Bellefonte Unit 3 and 4 COLA: Design Basis Flood Calc Review

Christopher Cook, Ph.D.
Senior Hydrologist
Hydrology Branch, DSER
Office of New Reactors, NRC

Summary of Effects on Water Level

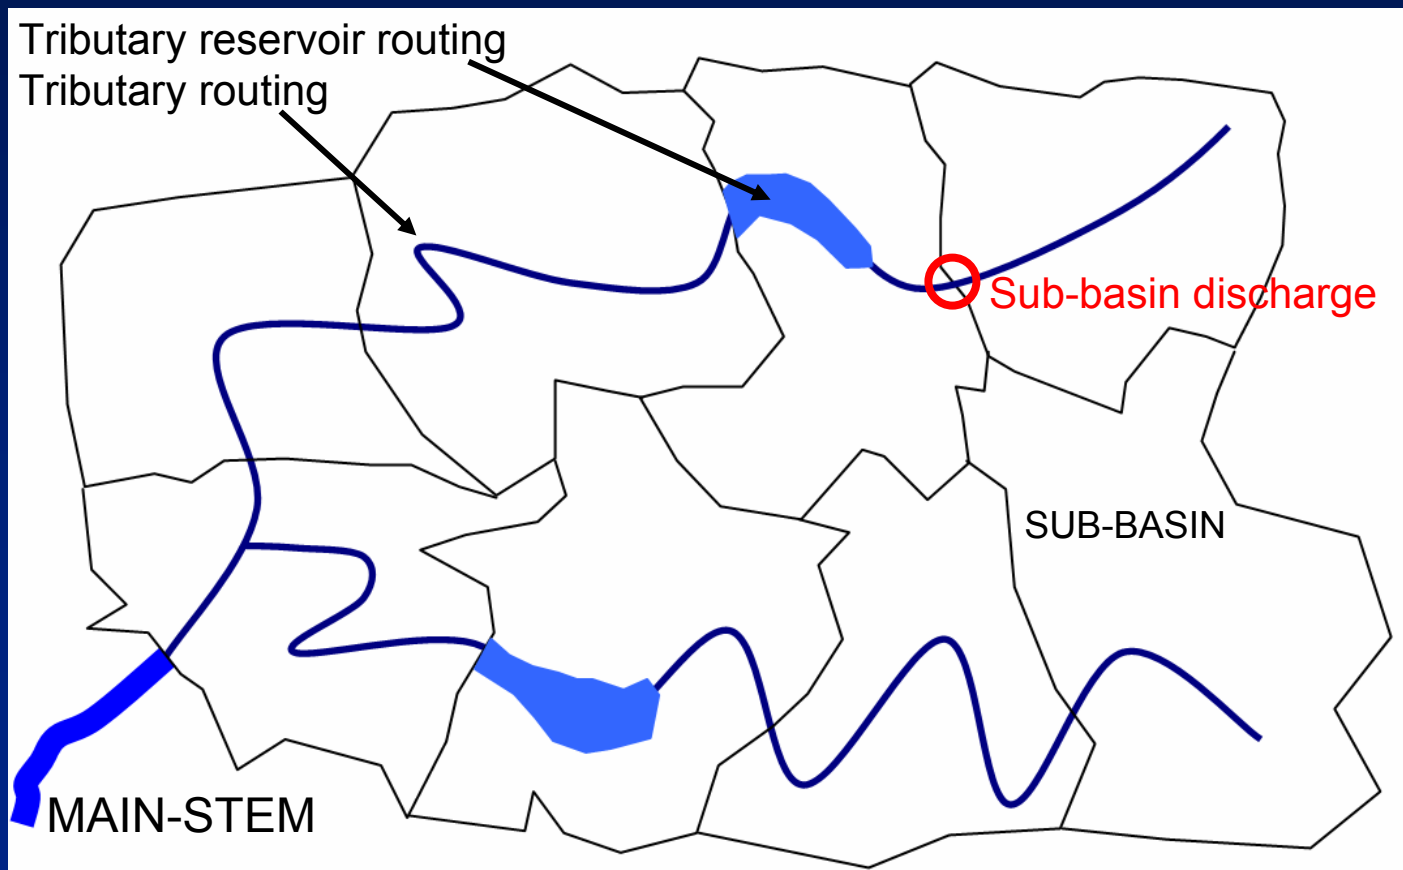
- Wind waves, including storm surge and run-up = +1.5 ft
- Dallas Bay Error = +1.3 ft
- Changing run-off from 89% to 100% = +4.7 ft
